**AERONAUTICAL ENGINEERS AUSTRALIA PTY LTD**

**AIRCRAFT DESIGN SPECIALISTS • AIRCRAFT WEIGHT CONTROL AUTHORITY****ENGINEERING ORDER****Number:** EO12566.001/1**Title:** Indicator Lamp Installations**Distribution:** Dinsdale and Associates

<b>Aircraft:</b>	<b>Model:</b>	<b>Regn. No:</b>	<b>Serial No.:</b>
Rockwell	114	VH-DDY	14280

**FIGURE 1: Indicator Lamp Locations.**

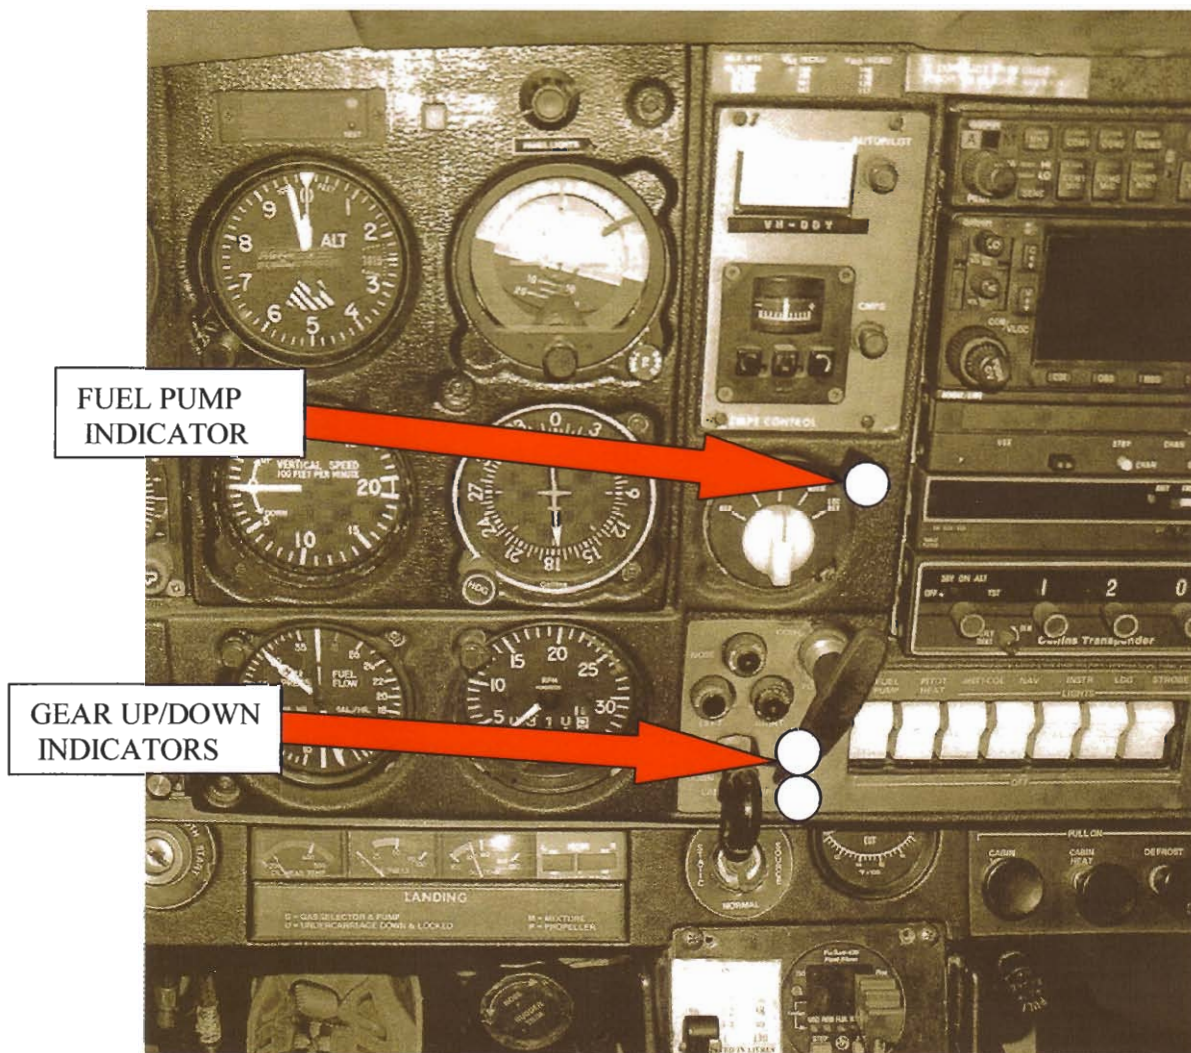
This engineering order approves the installation of 3 indicator lamps P/N MS25041-4.

- 3.1.1. Install the indicator lamps to the instrument panel to the locations indicated in Figure 1. Secure using supplied hardware.
- 3.1.2. Interwire the indicator lamps in accordance with Figures 2 and 3.
- 3.1.3. Placard each indicator to state its function as follows, FUEL PUMP, GEAR UP, GEAR DOWN. The text is to be a minimum of 3mm in height and is to be on a contrasting background such as black text on a white background or vice versa.

**FIGURE 2: Gear Up/Down Indicators**

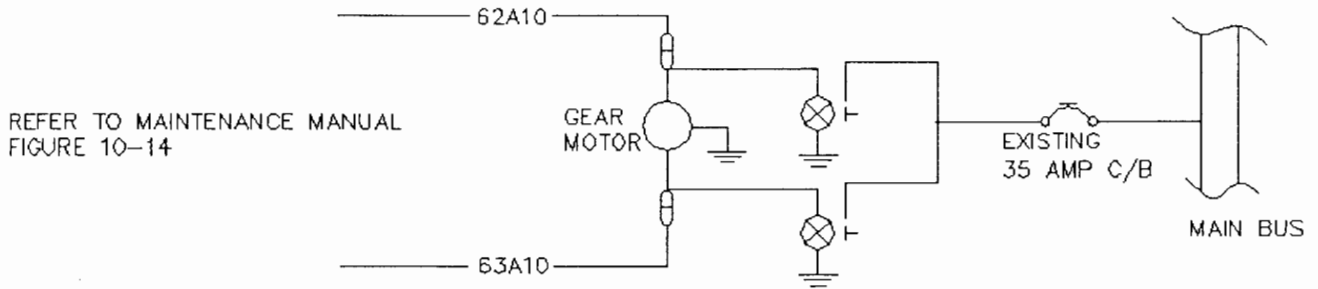
Two indicators are for the Gear Motor. One indicating Gear Motor Up, the other to indicate Gear Motor Down.

**FIGURE 3: Fuel Pump Indicator**

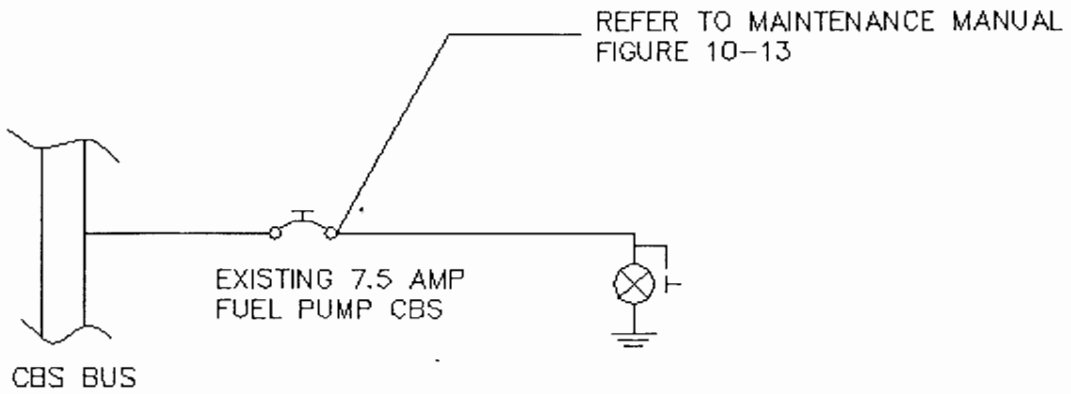
One indicator is for the auxiliary fuel pump to show when fuel pump is On.
